TOWN OF PARADISE VALLEY

Lot 29, Stone Canyon Amended II

Lot Split (LS-25-03)

Planning Commission

CONSTRUCTION COST ESTIMATE

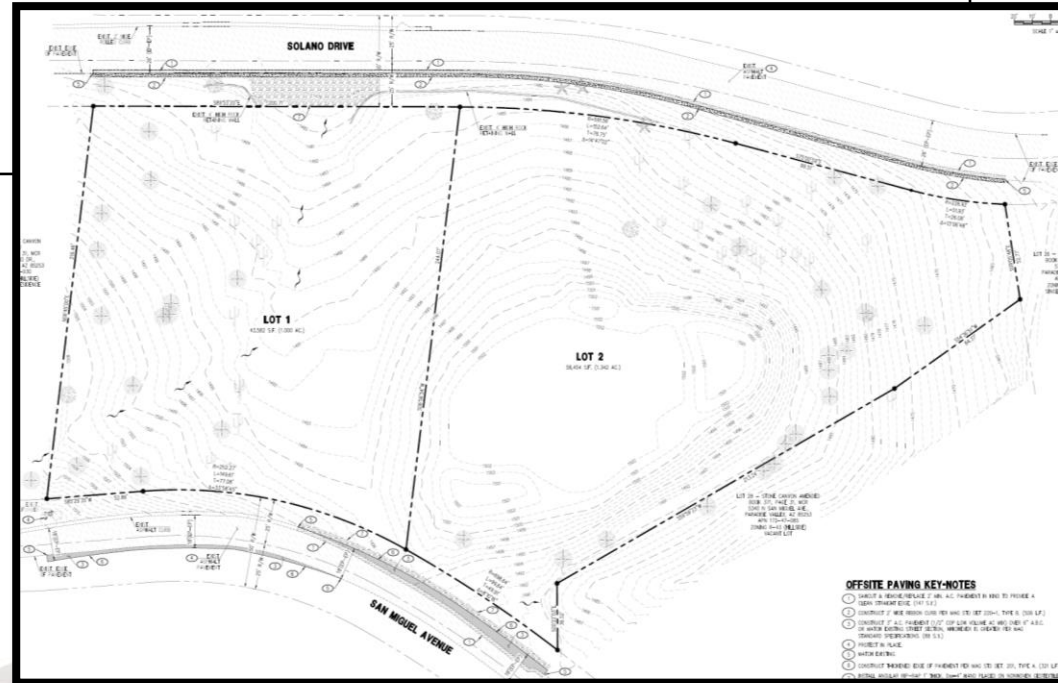
Submit right-of-way improvement and landscape plan and preliminary cost estimate

Submitted and meets Town requirements

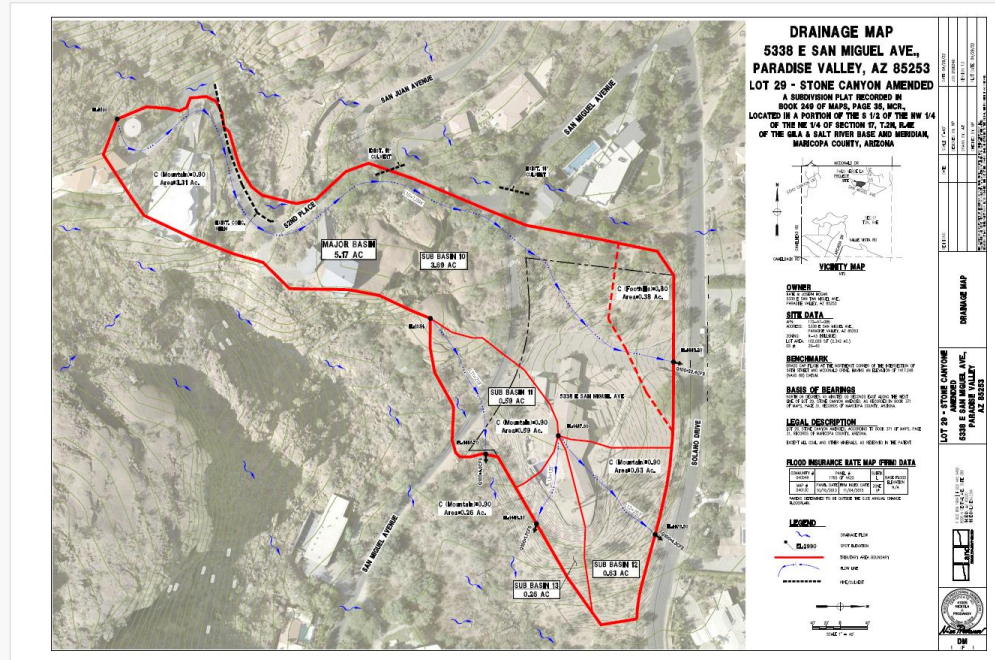
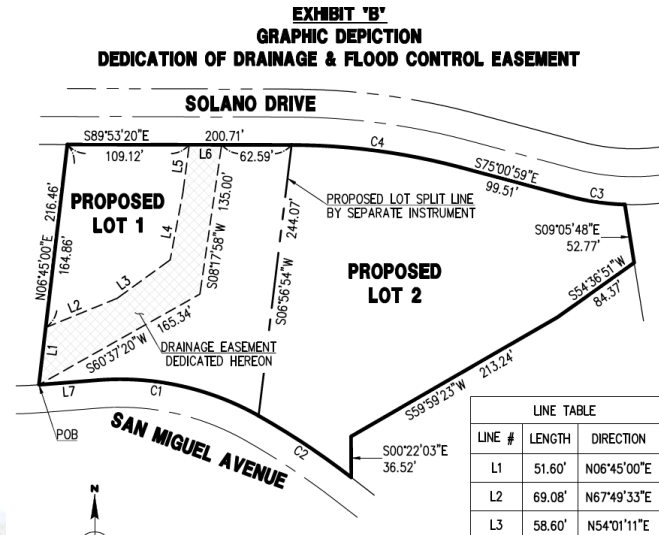
Sept 23 rd Discussion Points	Response
Discussed drainage	Preliminary drainage documents provided as typical for a lot split; detailed drainage documents part of hillside/permit review process

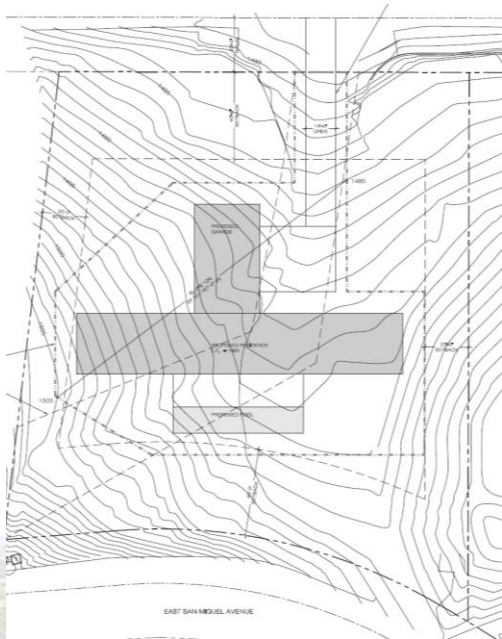
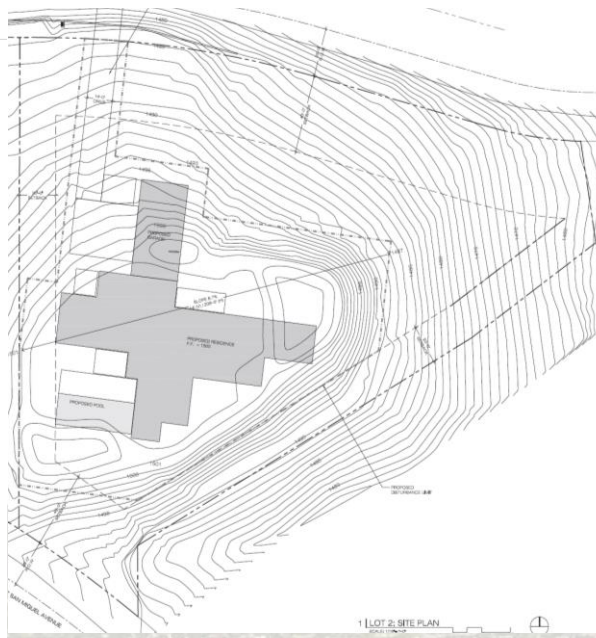
Inquired on buildable aspect of the lots

Sheets A100 and A101 demonstrate compliance; lot slope is 6.7% and 12% (8.33% full site, slope is below average compared to most hillside lots)

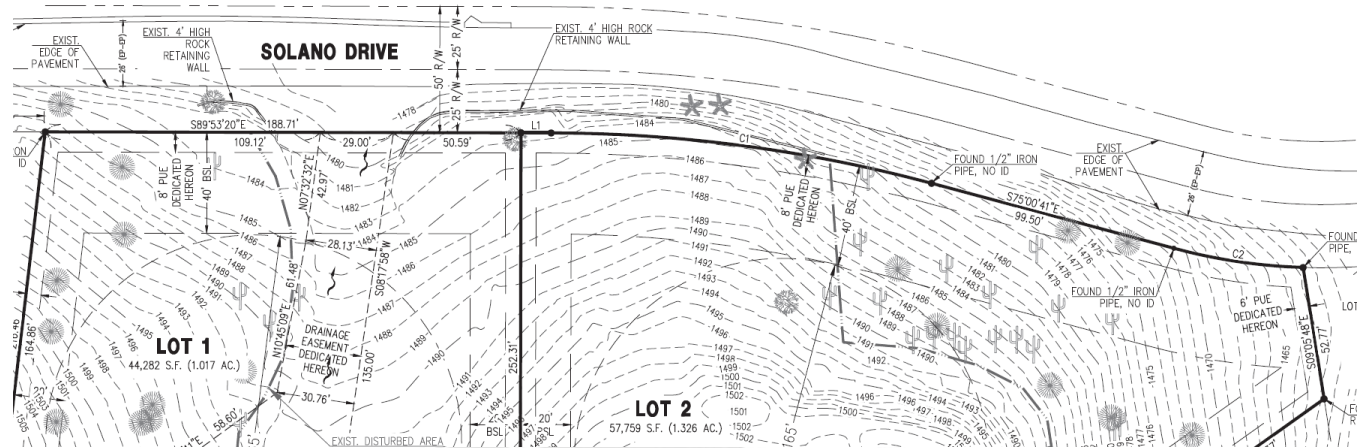
Sept 23 rd Discussion Points	Response
Reviewed existing retaining walls	Need to remain with an encroachment permit in process through the Town Engineering Division

ROADWAY – SOLANO DR & SAN MIGUEL AVE

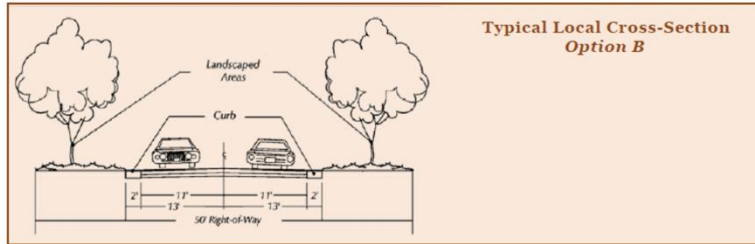
- Solano Drive & San Miguel Avenue are local streets
- Both streets comply with Town right-of-way requirements
- Both streets will require curb and/or pavement improvements
- Solano Drive to meet Typical Local Cross-Section Option B

- c. Install the right-of-way half street improvement to include pavement and curbs along Solano Drive per the Town’s Typical Local Cross-Section Option B and outlined in the Offsite Paving Plan prepared by Land Development Group, dated September 29, 2025.

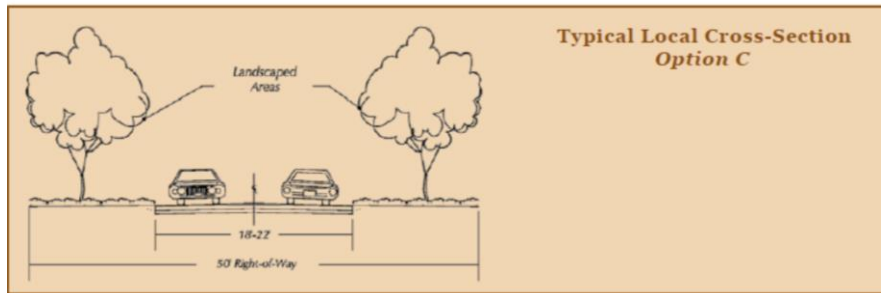
- San Miguel Avenue to meet Typical Local Cross-Section Option C

- d. Install the right-of-way half street improvement to include asphalt along San Miguel Avenue per the Town’s Typical Local Cross-Section Option C and outlined in the Offsite Paving Plan prepared by Land Development Group, dated September 29, 2025.

DRAINAGE

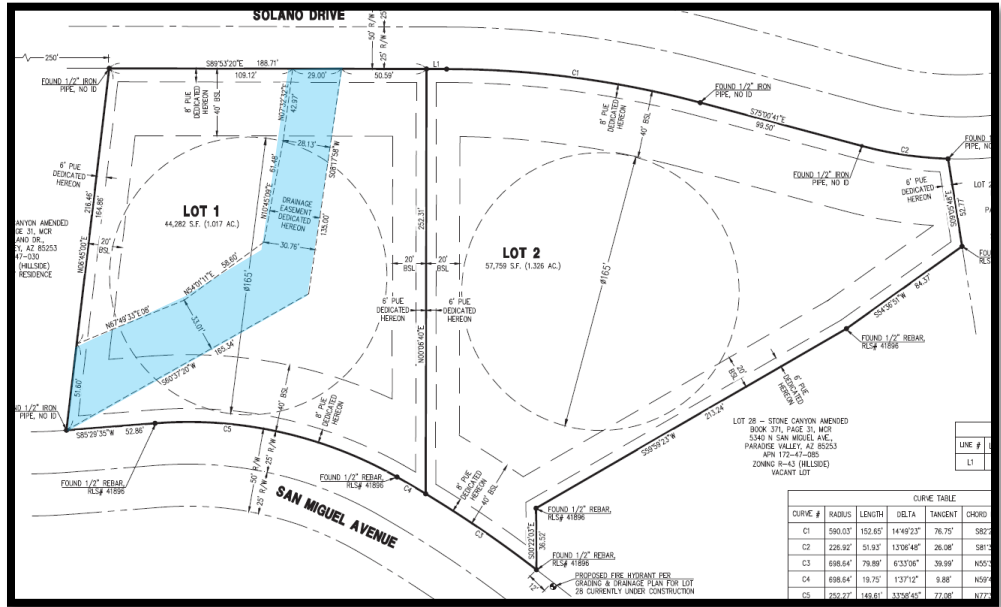
- Each lot will be required to meet drainage requirements as part of hillside/building permit process
- Wash easements that meet minimum width/depth, and cubic feet per second standards shown on the plat

- c. Provide the Town with a Drainage Easement and Maintenance Agreement for Lot 1. This form shall be submitted and approved by the Town and recorded with the Maricopa County Recorder’s Office.

FIRE PROTECTION

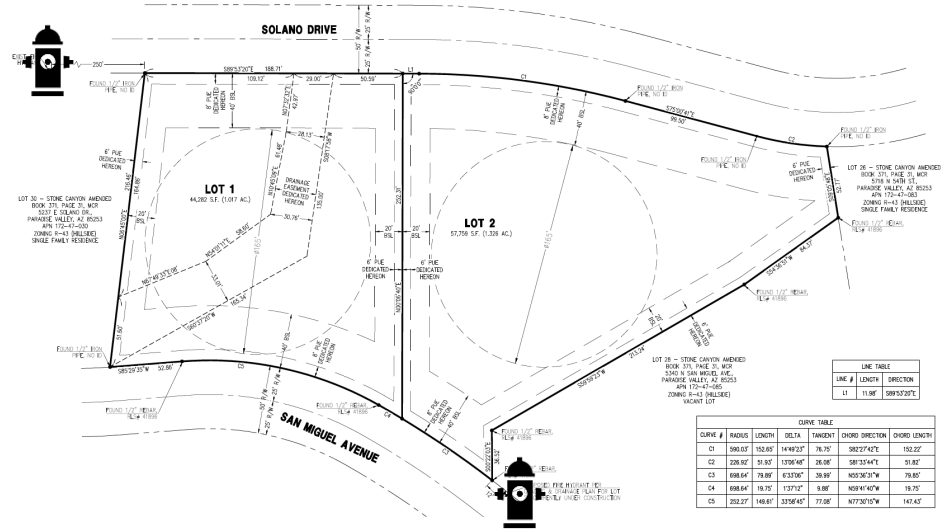
- Both lots will have access onto public roadway
- Existing fire hydrant 250' from Lot 1 on Solano Drive
- New hydrant to be added adjacent to Lot 2 on San Miguel Avenue
- Flow rate from the water impact study is compliant with the minimum code requirement of 1,500 gpm (at 4,099 gpm)

- a. Install the water infrastructure, including the new fire hydrant and inspection by the Town.
 - b. Install the right-of-way landscape improvements as outlined in the Stone Canyon Amended II R.O.W. Landscape Plan, prepared by The Construction Zone and dated July 31, 2025.
